URGENT – FIELD SAFETY NOTICE
Concerto & Basic shower trolley

Date:	2019- MMM-DD
Product Issue:	Concerto & Basic shower trolley – Potential unintentional drop of safety side panel
Affected Product:	<ul style="list-style-type: none"> ✓ Concerto & Basic shower trolleys manufactured between November 2018 and June 2019; Serial number ranges: P0512263 to P0551621 ✓ Concerto & Basic shower trolleys fitted with the affected spare parts (safety catch) part no. 8451622, 8546608, S8533571-031, S8533572-031, S8533570-031 S8542201-014, S8523559-031, 100-805-03, 100-806-03 during service between 2018-Nov-27 and 2019-Jun-14
Affected Serial No.:	Attachment A
Resolution:	Safety catches replacement in order to ensure the device is operating safely
Field Safety Notice:	FSN-POZ-002-2019
Pages:	3, Attachment A & Customer Response Form

Image 1

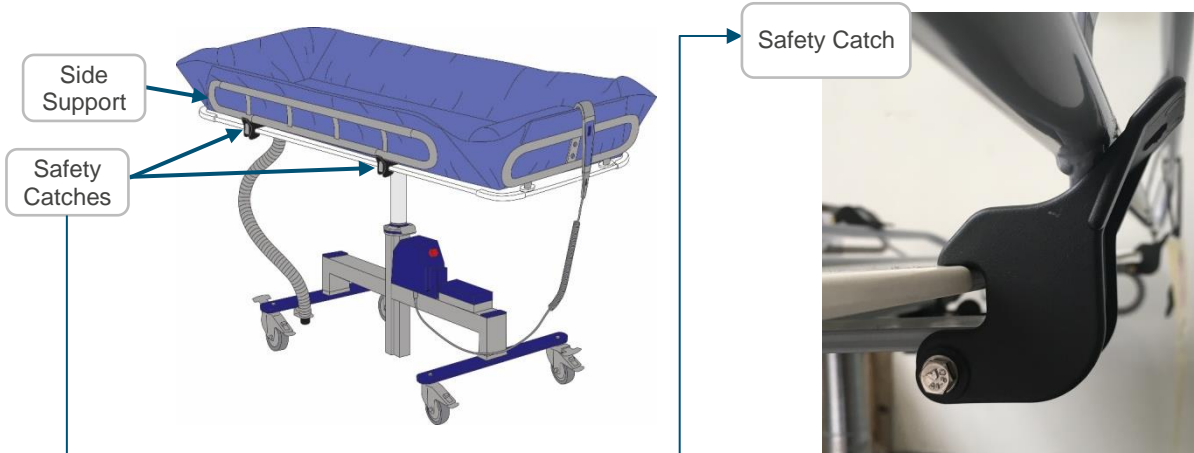
Each Concerto & Basic shower trolley is equipped with two Side Supports, one on each side of the shower trolley (Image 1). Each side support is secured by two (2) Safety Catches (Image 2) which are used to fold down the supports as well as secure the support in the raised position.

Arjo has become aware that any of the 4 Safety Catch(es) may exhibit a mechanical failure (break in one of the arms of Safety Catch), which in certain circumstances may contribute to the Side Support unintentionally opening and may lead to a potential risk of patient fall, leading to possible injuries to patient and/or caregiver.

1. Verify the condition of all 4 Safety Catches attached to your device. If you notice the break (as shown in Image 3) withdraw the trolley from use.

IMPORTANT: The device may stay in use until the upgrade is performed, providing that the following instructions are carefully followed:

- ✓ It is recommended that the Safety Catches on the shower trolley Side Supports be inspected daily to ensure any of the catches are not broken as show on the Image 3.
- ✓ The patient is not left unattended at any time.
- ✓ The patient is fully assisted so that he/she does not grab, push or lean against the Side Supports during showering activities.
- ✓ Caregivers should limit pulling and pushing of the Side Supports with excessive force.
- ✓ **Note:** always adhere to the Safe Working Load as outlined in the IFU.
